AIR - HPT/LPT ACC ACTUATOR ASSEMBLY - NEW LVDT COVER INTRODUCTION AND REWORK OF LVDT COVER AND ACTUATOR BODY BOSS - CATEGORY CODE 4 - MOD.ENG-75-0008

AIR - V2500 - HP/LP ACC ACTUATOR, PART NUMBER 5860017-109 & -111. MODIFICATION OF SPRING RETAINER SYSTEM, REWORK OF LVDT OVER, ACTUATOR BODY AND WASHER REPLACEMENT AND UPGRADE TO A -113 CONFIGURATION.

5860017-75-51

Straight Edge Check
Figure 1

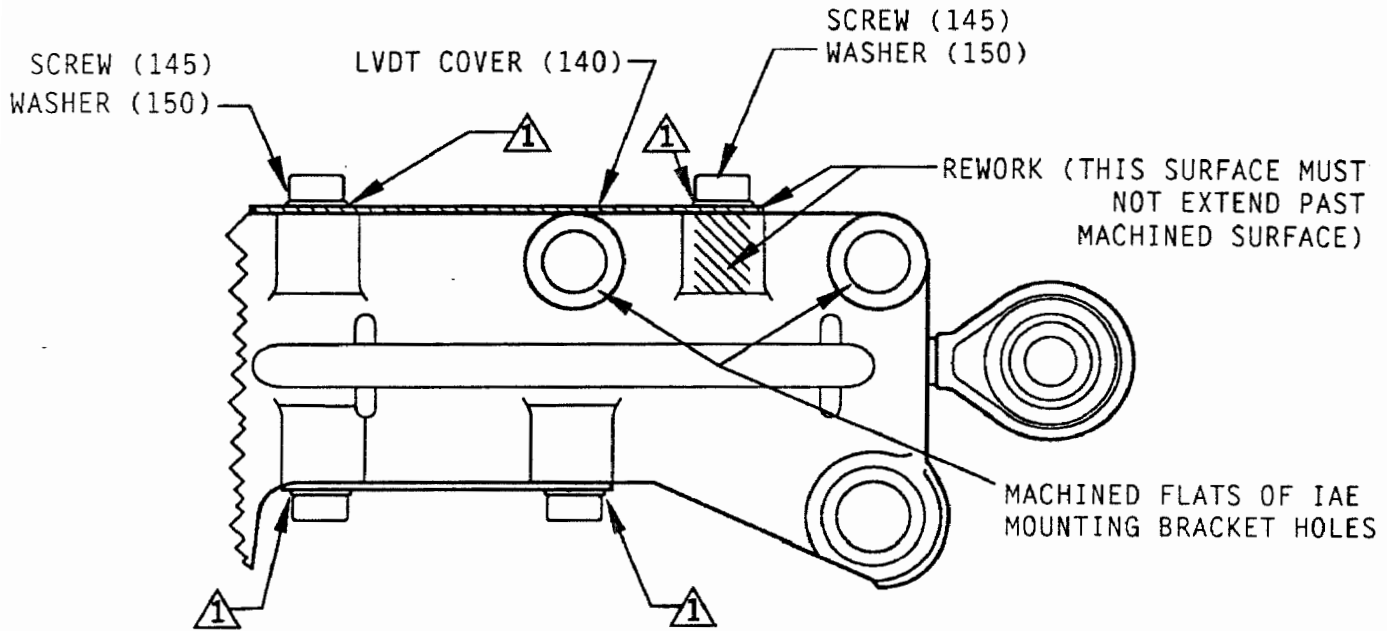
<u>TASK</u>	<u>MAN HOURS</u>
Check the actuator body and LVDT cover for excess material as shown in Figure 1 in this service bulletin.	0.25
Remove the insulation blanket and LVDT cover from the actuator assembly.	0.25
Rework the actuator body and/or LVDT cover.	1.00
Reassemble the LVDT cover and insulation blanket on the actuator assembly.	0.50
Reidentify the actuator assembly.	<u>0.50</u>
TOTAL	2.50

- A. Option 1: For operators with a 5860017-109 Actuator, see paragraph 1.G.(1) in this service bulletin.
- B. Option 2: Operators with a 5860017-111 Actuator shall perform the following instructions.
- (1) Unless otherwise noted, refer to Parker Hannifin Corporation, Component Maintenance Manual 75-24-52, IPL Figure 1, and Figure 1 and 2 in this service bulletin for all item numbers referenced in these instructions.
 - (2) Check the actuator assembly mounting side with a straight edge, as indicated in Figure 1 of this service bulletin and as follows:
 - (a) Lay a straight edge flat across the actuator body machined raised flats. Interference with either the LVDT cover edge or the actuator body boss should not be present.
 - (b) If interference occurs, rework the actuator body boss and/or the LVDT cover edge as instructed in Paragraph 2.C.

(c) If no interference occurs between the straight edge and the actuator body boss or the LVDT cover, modify the actuator as follows:

Rework Details
Figure 2

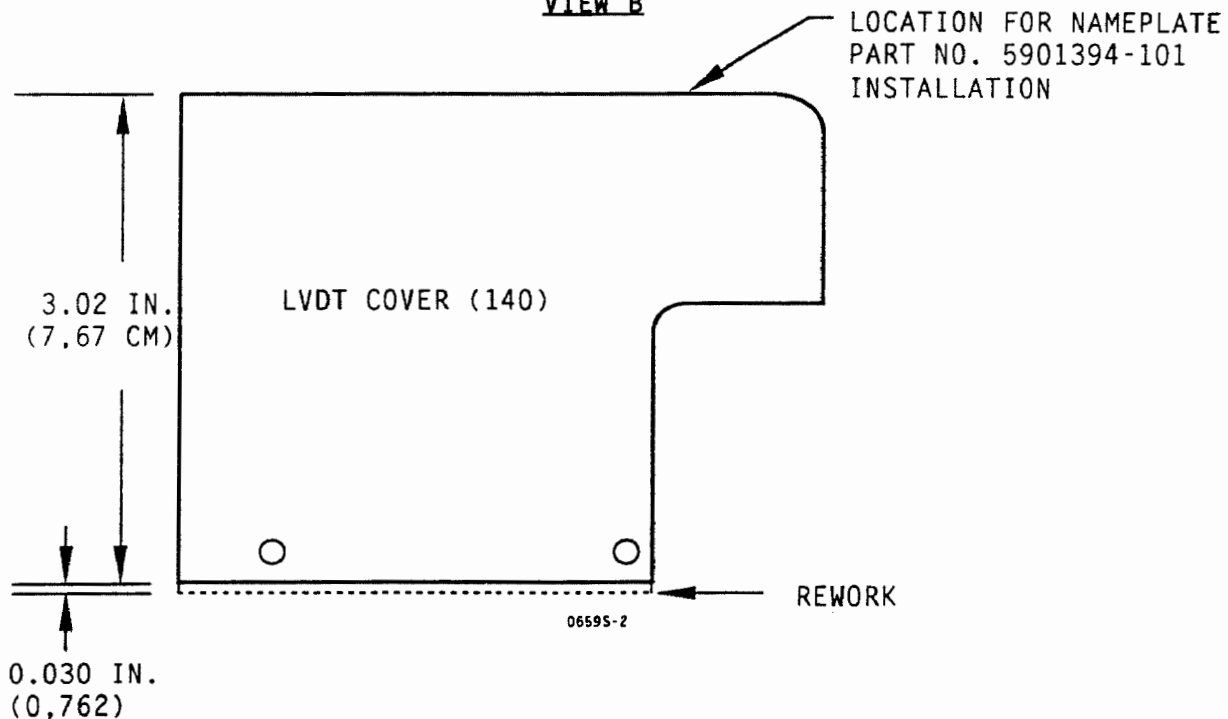
VIEW A

- ⚠ THE 5860017-111 ACTUATOR REQUIRES THE REPLACEMENT OF FOUR WASHERS (150) WITH FOUR NEW WASHERS P/N NAS620C6 (4 PLACES).

VIEW B

- 1) Refer to Figure 2, View A, in this service bulletin, and remove four screws (145) and four washers (150) from the noted locations on the LVDT cover.
- 2) Reinstall four screws (145) with four new washers, Part Number NAS620C6, in the noted locations on the LVDT cover.
- 3) Torque four screws (145) 10 to 11.5 lb.in. (1.13 to 1.30 N·m).
- 4) Proceed with Paragraph 2.D.(2)(c) and reidentify the actuator to indicate completion of this service bulletin.

- (1) Remove the insulation blanket (5) from the actuator assembly.
- (2) Remove five screws (145) and five washers (150) from the LVDT cover (140); then remove the LVDT cover.
- (3) Carefully rework to remove any excess material from the actuator body boss until interference with the straight edge layed flat across the actuator body machined raised flats is no longer present. (See View A.)

- (4) Carefully rework to remove 0.030 in. (0.762 mm) from the edge of the LVDT cover (140). (See View B.)
- (5) Debur the reworked surfaces.
- (6) Apply a light coating of Chem Film per MIL-C-5541, Class 3, to all reworked surfaces.
- (7) Reposition the LVDT cover (140).
- (8) Refer to Figure 2, View A, and install four new washers, Part Number NAS620C6, in the noted locations; then reinstall one washer (150) and five screws (145).
- (9) Reinspect per Paragraph 2.B.(1). If rework is satisfactory, continue with the following procedures. If rework is not satisfactory, repeat rework instructions until satisfactorily completed.

(10) Torque five screws (145) 10 to 11.5 lb.in. (1.13 to 1.30 N·m).
